Access Compliance Report Public Rights-of-Way (Curb Ramps)

Intersection ID: N/A	Main Street: PINEVILLE-MATTHEWS_RD	Cross Street: KETTERING_DR	Location: NE
ADA ID: 5E39409AB587	Ramp Type: PerpDiag	Initial Pass/Fail: Fail	Overall Compliance: No Severity Score: 12.5

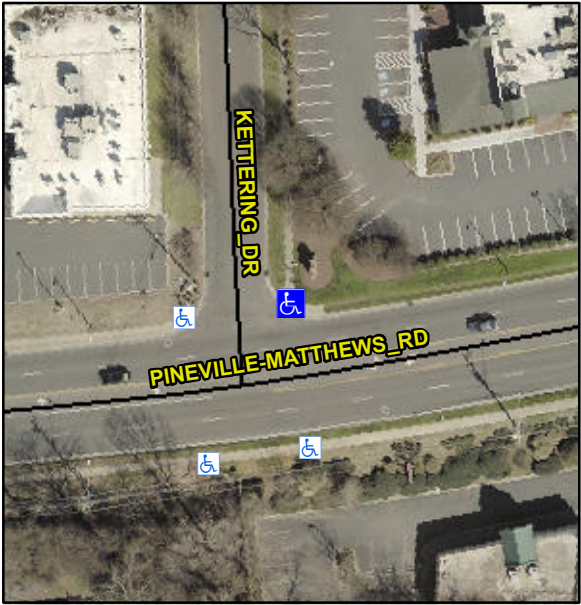
PROW/ADA:
R304.2.2

Compliance	Description	Data	Compliance	Description	Data
N/A	Ramp Length (in)	57.5	No	Ramp Slope (%)	9.8
Yes	Ramp Width (in)	48.0	Yes	Ramp XSlope (%)	1.1
N/A	Flare Type LT	N/A	N/A	Flare Type RT	N/A
N/A	Flare Slope LT (%)	N/A	N/A	Flare Slope RT (%)	N/A
N/A	Flare Traversable LT?	N/A	N/A	Flare Traversable RT?	N/A
N/A	Landing Length (in)	N/A	N/A	DWS Provided?	N/A
N/A	Landing Width (in)	N/A	N/A	DWS Contrast?	N/A
N/A	Landing Slope (%)	N/A	N/A	DWS Length (in)	N/A
N/A	Landing X Slope (%)	N/A	N/A	DWS Full Width?	N/A
N/A	Landing Curb? (Y/N)	N/A	N/A	DWS Offset (in)	N/A
N/A	Shared Landing?	N/A			
N/A	Gutter Ponding?	N/A	N/A	Gutter Slope (%)	N/A
N/A	Gutter Lip Ht (in)	N/A	N/A	Gutter X Slope (%)	N/A
N/A	Painted X Walk1?	No	N/A	Painted X Walk2?	No
	X Walk 1 Direction	To W		X Walk 2 Direction	To S
N/A	X Walk 1 Width (in)	N/A	N/A	X Walk 2 Width (in)	N/A
	X Walk 1 Slope (%)	3.5		X Walk 2 Slope (%)	1.1
	X Walk 1 X Slope (%)	0.6		X Walk 2 X Slope (%)	3.3

Possible Solutions:
Remove & Replace Curb Ramp With Two New Directional Ramps or Equivalent.
